GE Consumer & Industrial Service Bulletin

LAUNDRY - HYDROWAVE WASHERS HL 01-09

JANUARY 2009

OPEN COIL ON MODE SHIFTER ASSEMBLY

Motor Inverter Label

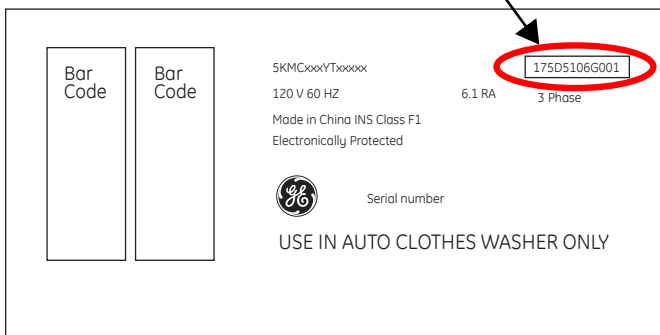
NOTE: Some motor inverter assemblies have a second label on the top cover with a different part number. Always use this top label (if present) to determine the current motor inverter assembly part number.

Check the resistance of the mode shifter coil. If there is no resistance, the coil is open and the mode shifter assembly must be replaced. In addition to the mode shifter, replace the motor inverter assembly if the part number on the motor label is one of the following:

175D5106G014
175D5106G015
175D5106G016
175D5106G026
175D5106G027
175D5106G028
175D5106G029
175D5106G030
175D5106G031
